GLASTAR SERVICE BULLETIN 19

Subject: Elevator and trim tab hinge edge margin

Applicability: All GlaStar kits shipped prior to the publication of *Assembly Manual* Revision C.

Figure 1: Trimming the Horizontal Stabilizer Nose Ribs

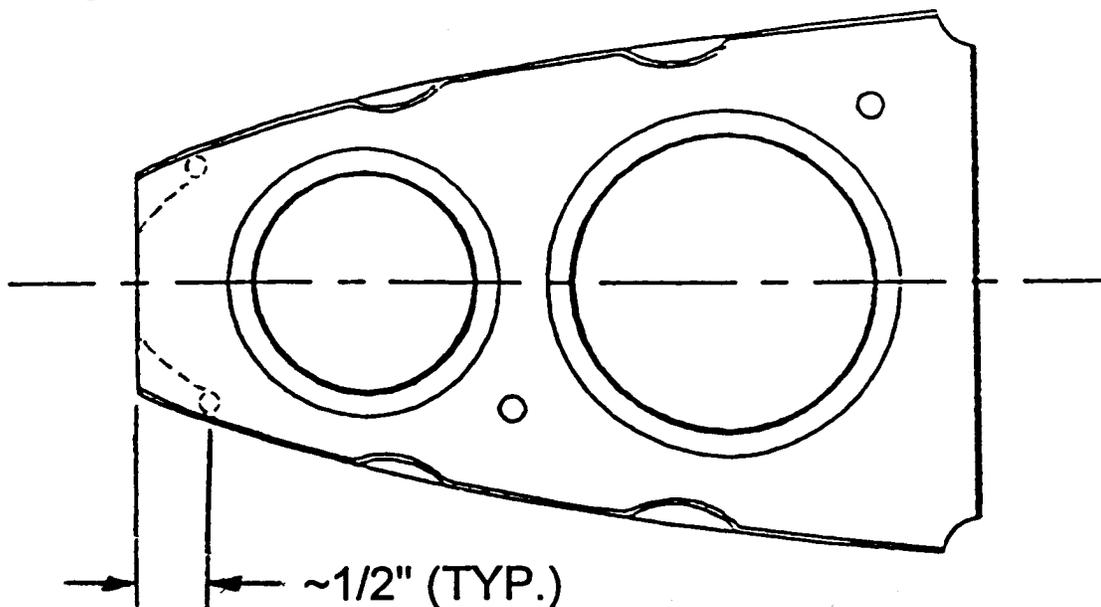
6. In January 1997, the stabilizer nose ribs were shortened by roughly 1/4" to an overall length of about 3-3/4". (The original ribs were P/N 302-00009-01; the new ribs are designated -03.) This will make it easier to pull the stabilizer skins back over the spar/rib structure to their proper position relative to the aft spar and hinges. (This change will take effect when the next run of ribs is produced.)

Recommended Action: If you have not yet drilled or riveted your horizontal stabilizer skins and you received **first-run** nose ribs [P/N 302-0009-01], you can minimize the edge margin problems outlined above by trimming your stabilizer nose ribs. Figure 1 shows how the ribs should be trimmed. Begin by drilling a small hole through the rib web about 1/2" aft of the leading edge immediately above or below the rib flange. A 1/8" or #30 bit will be just about right. Then use a pair of snips cut away the web as shown by the dashed line, leaving only the flange itself. Sand or file the cut edges smooth.

Note If you received **second-run** nose ribs [P/N 302-0009-03], do not trim them; they are already shortened.
